**ADDENDUM NO. 2**

Re: **GS# 101-328**  
Dormitory Renovations  
Alcorn State University  
Lorman, Mississippi

**ADDENDUM NO. TWO (2)**

GS# 101-328  
Dormitory Renovations Alcorn State University  
Lorman, Mississippi  
ERG P.N. 23.123

Enlarged Demolition Plan - Plumbing (Burrus Hall) 1/4" NORTH

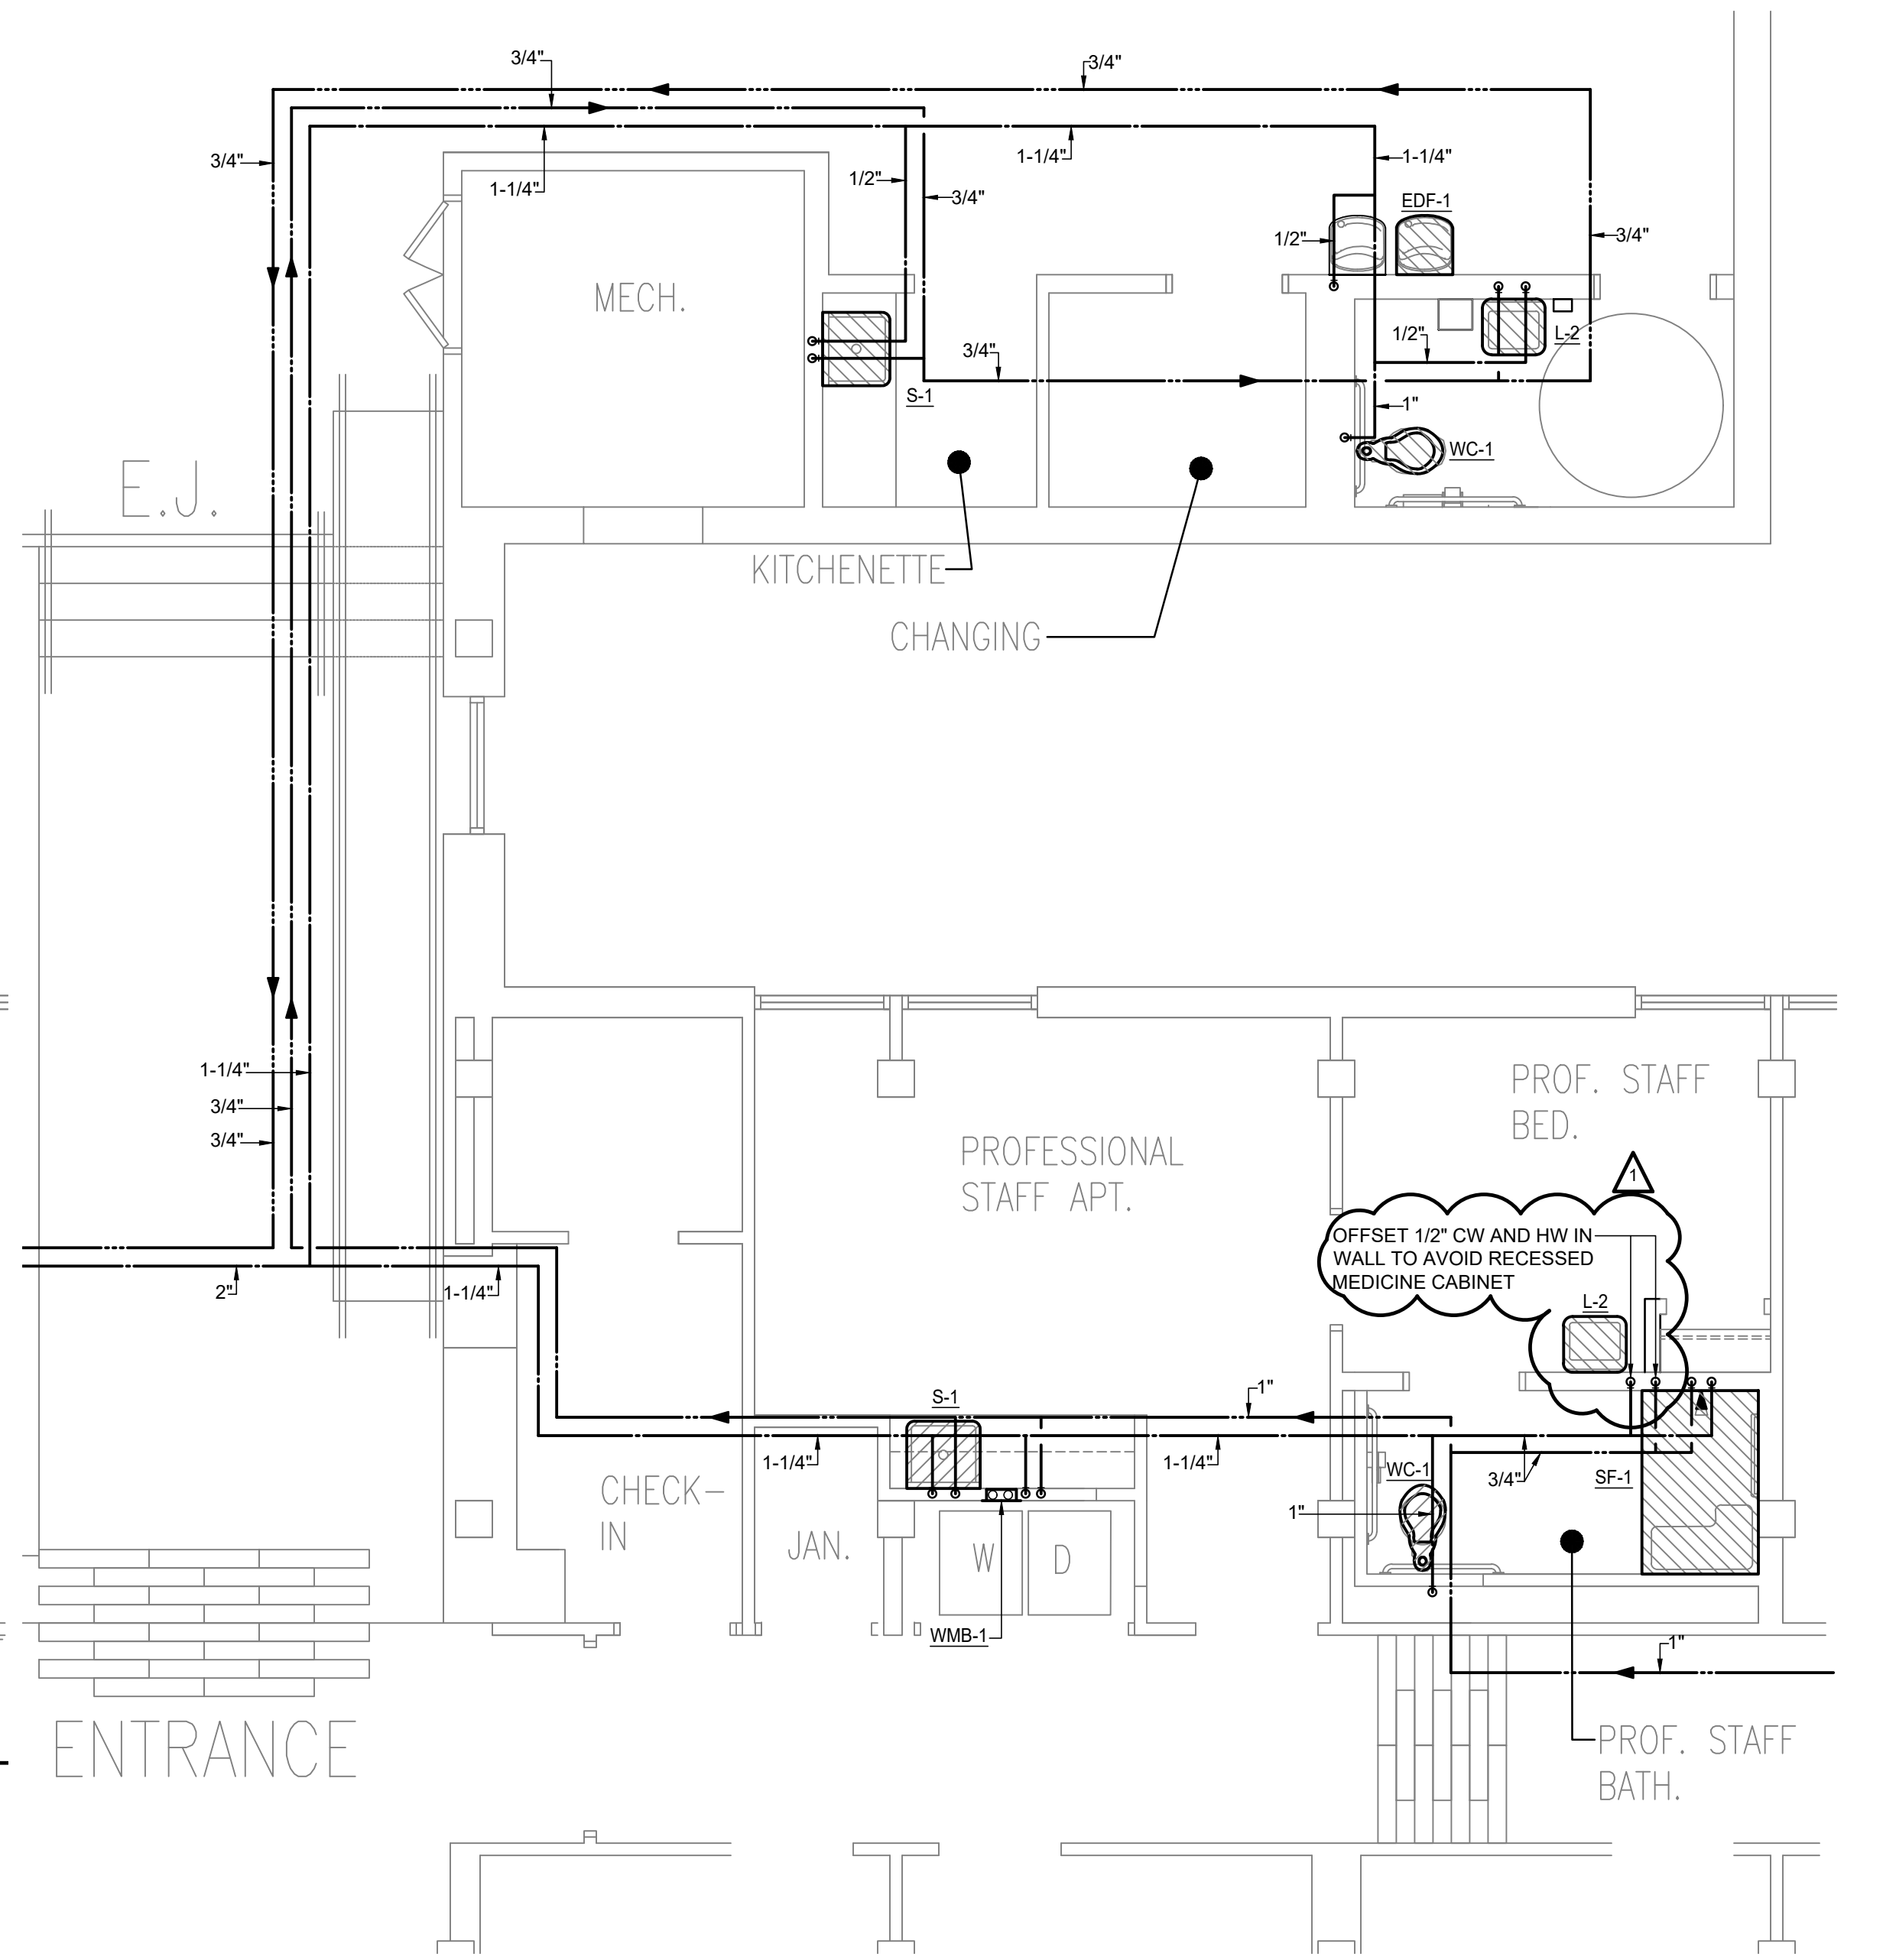
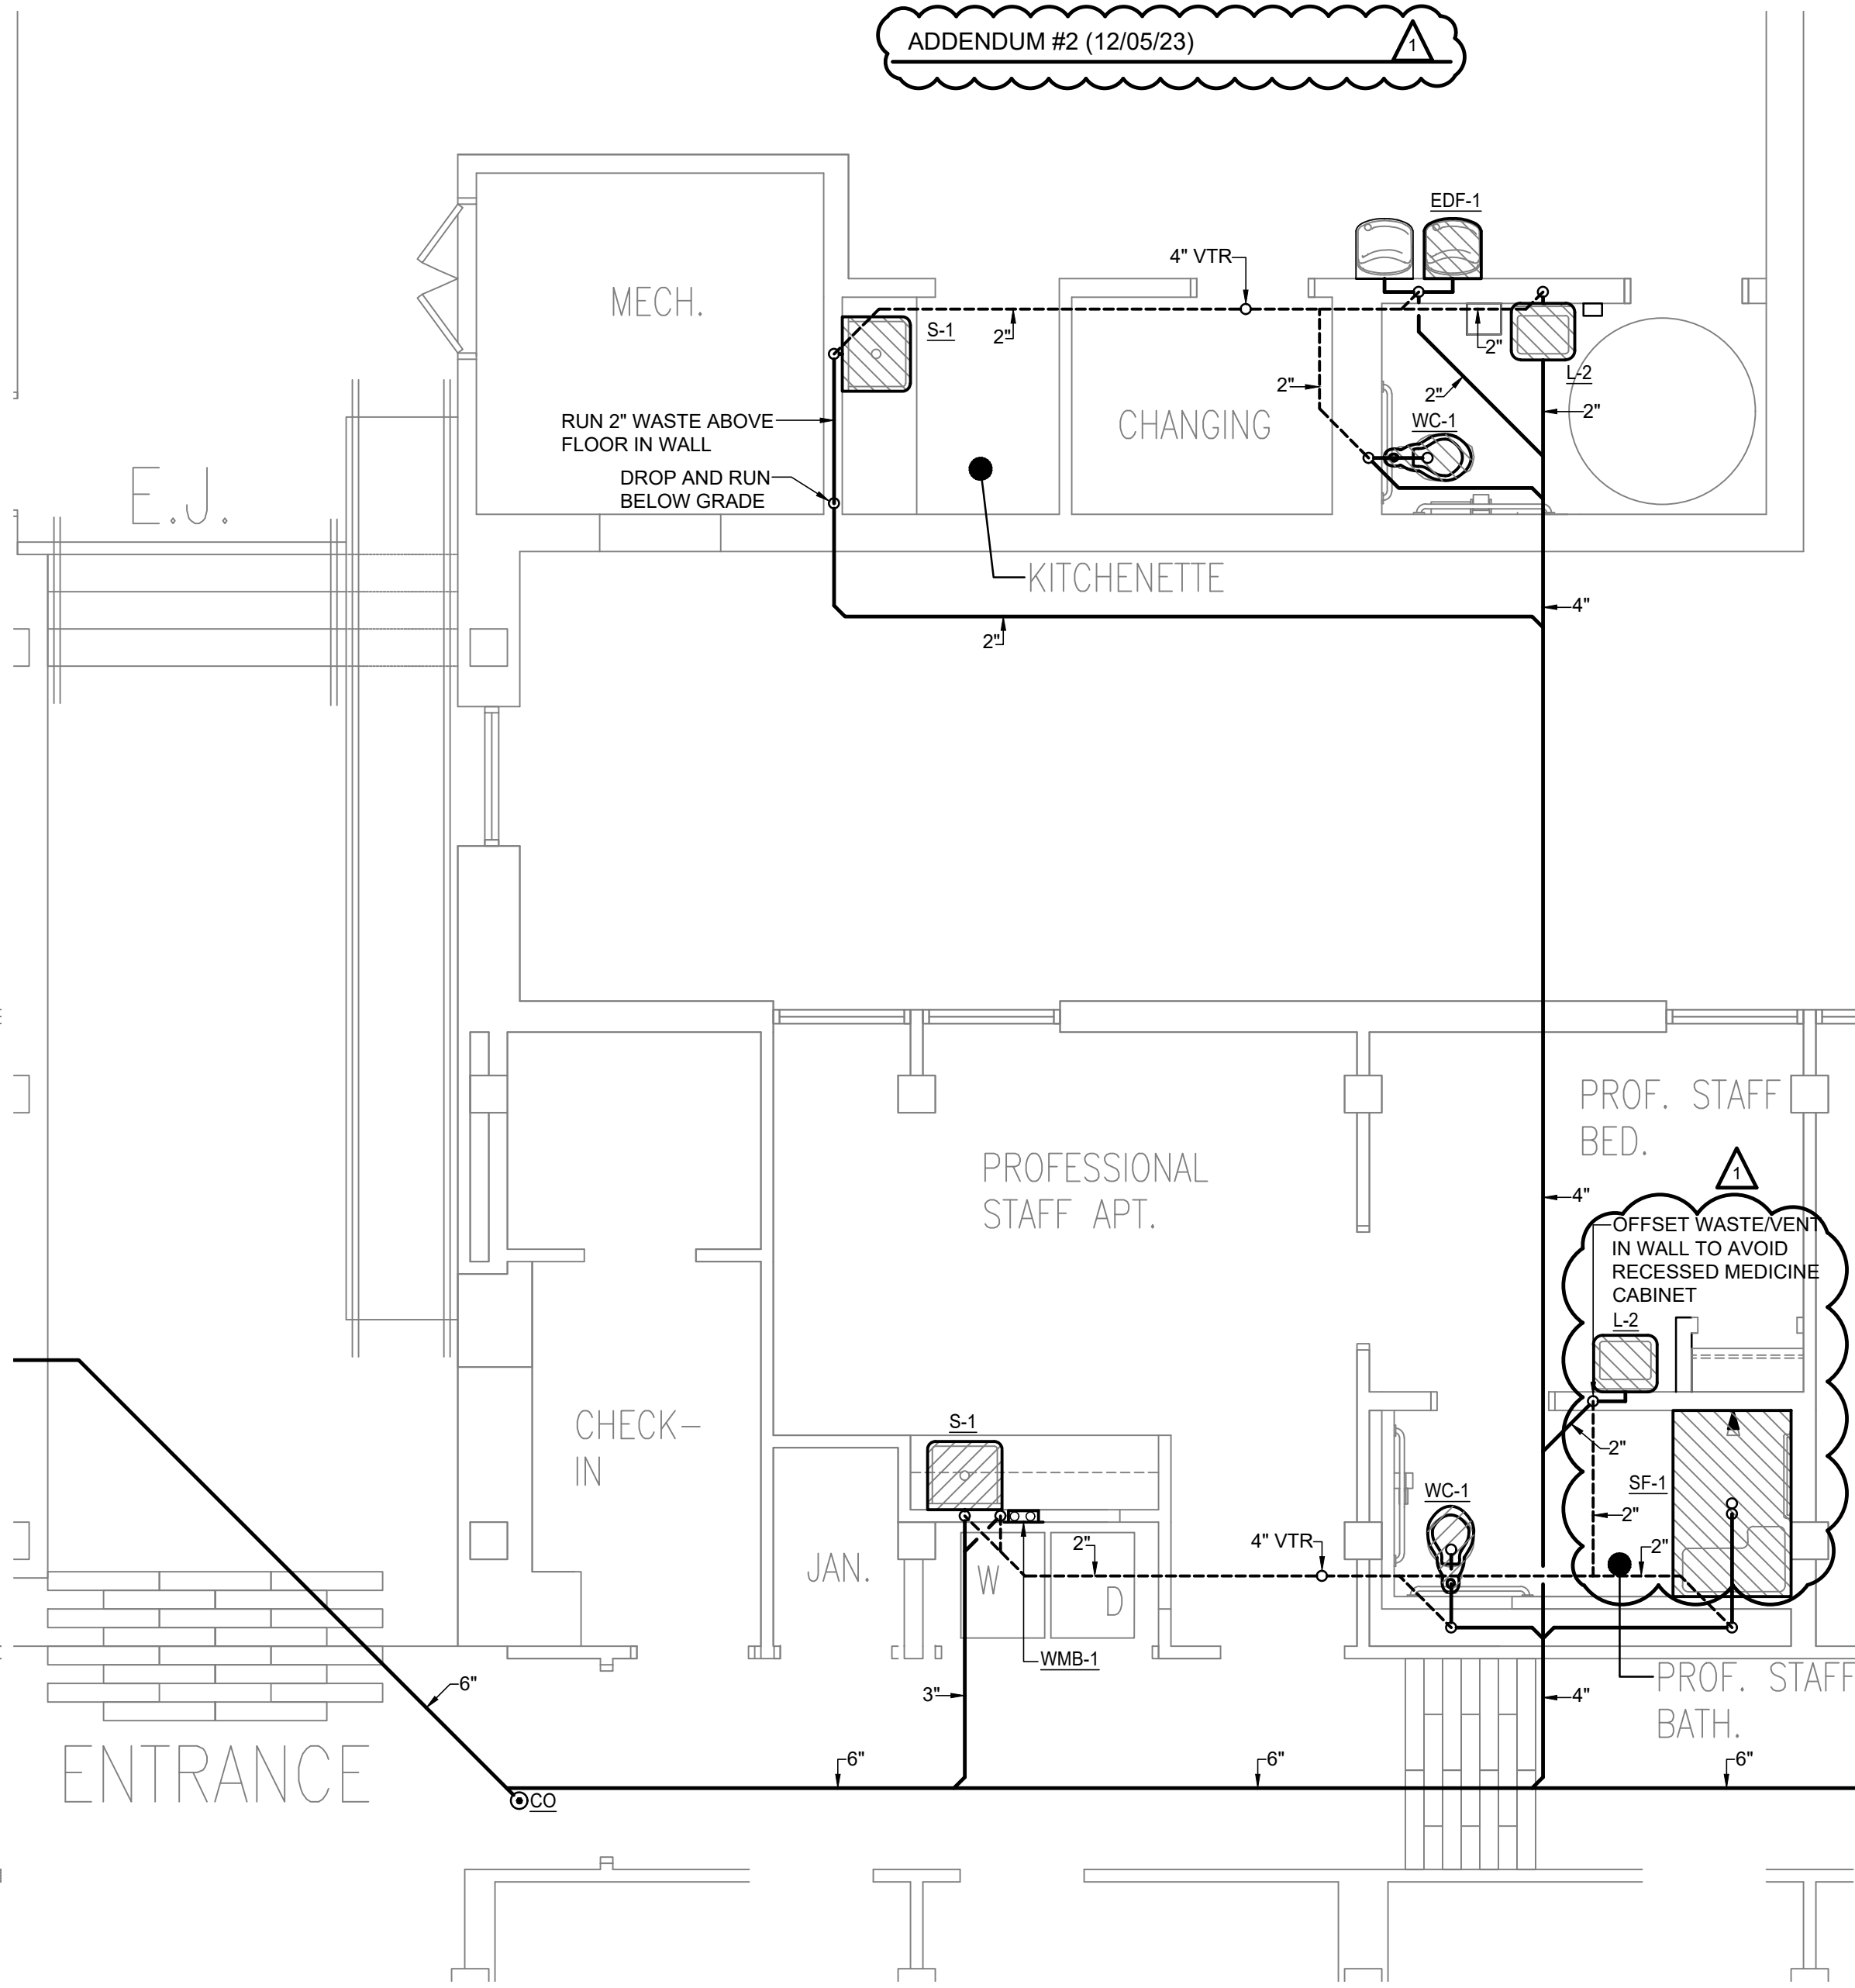
- A. Sheet P0.1: Revised Plumbing General Notes.
- B. Sheet P2.2: Relocated cold, hot, and hot water recirc mains from Dorm R24 to R30.
- C. Sheet P3.0: Revised piping at L-2 located in Prof. Staff Bed.
- D. Sheet P3.1: Revised filtration system and added Make/Model.
- E. Sheet P3.7: Revised piping at L-2 located in Professional Staff.
- F. Sheet P3.8: Revised filtration system and added Make/Model. Revised routing of cold, hot, and hot water recirc piping up to first floor.

- GENERAL NOTES:**
- A. REMOVE ALL EXISTING DOMESTIC WATER, WASTE/VENT PIPING, HANGERS, SUPPORTS, ETC.
  - B. CAP-OFF AND ABANDON ALL WASTE PIPING THAT IS RUNNING BELOW BASEMENT AND FIRST FLOOR SLAB UNLESS NOTED OTHERWISE.
  - C. SEE ARCHITECTURAL FOR SLAB REPAIR DETAIL AT SLAB-ON-GRADE CONDITIONS.
- PLAN NOTES:**
- 1. EXISTING WATER CLOSET AND ASSOCIATED PIPING IS TO BE REMOVED AND REPLACED.
  - 2. EXISTING LAVATORY AND ASSOCIATED PIPING IS TO BE REMOVED AND REPLACED.
  - 3. EXISTING BATHTUB AND ASSOCIATED PIPING IS TO BE REMOVED AND REPLACED.
  - 4. EXISTING ELECTRIC DRINKING FOUNTAIN TO BE ADJUSTED TO A.D.A. HEIGHT. REMOVE AND REPLACE ALL PIPING.
  - 5. EXISTING SINK AND ASSOCIATED PIPING IS TO BE REMOVED.
